**IN THE DRAWINGS:**

The attached sheets of drawings include changes to FIGS. 2, 7 and 7A. These sheets, which include FIGS. 1-2 and 7-7A, replace the original sheets including FIGS. 1-2 and 7-7A.

Fig. 2

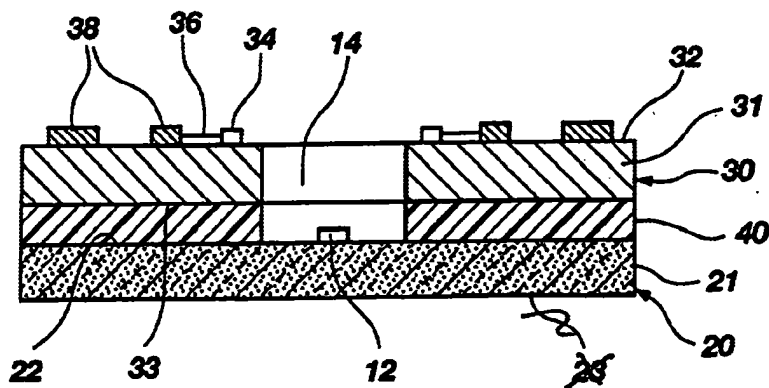
Specifically, FIG. 2 has been revised to delete the reference numeral "23" and its corresponding lead line; FIG. 7 has been revised to delete one of the lines within first small hole 74, to revise the dashed line indicating aperture or slot 14 and to fix the left-hand corner; and FIG. 7A has been revised to increase the height of second wider hole 76 by moving the lowest line to indicate the same height as the edge of substrate element 31 and to fix the left-hand corner. No new matter has been added.
